Certificate of Appropriateness
302 Lathrop St
November 2, 2020

Proposed Work

- Replace demolished garage with new compatible garage

AMERICAN'S VINYL WINDOW

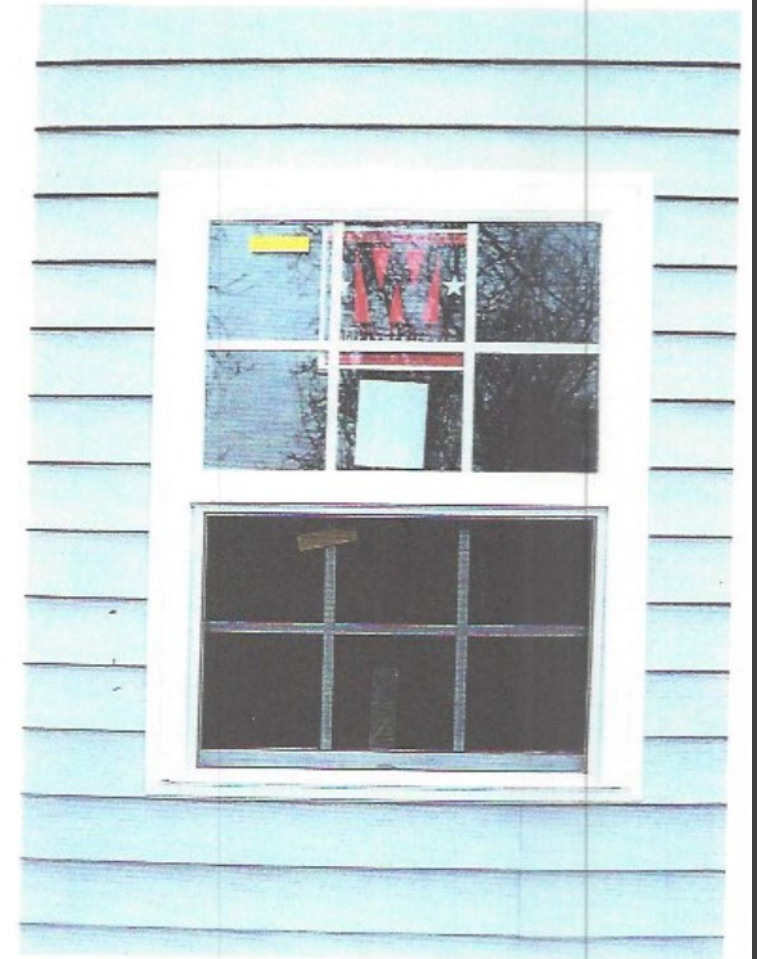
1. Submittal of new garage vehicle door that is in keeping with the style of doors found on similar garages within 200 feet, to be approved by staff
2. Submittal of new window specifications for simple one-over-one windows, to be approved by staff
3. Submittal of drawings of the proposed new rear entry or pictures of the current rear entry configuration for approval by staff due to the unapproved removal of the nonhistoric rear deck
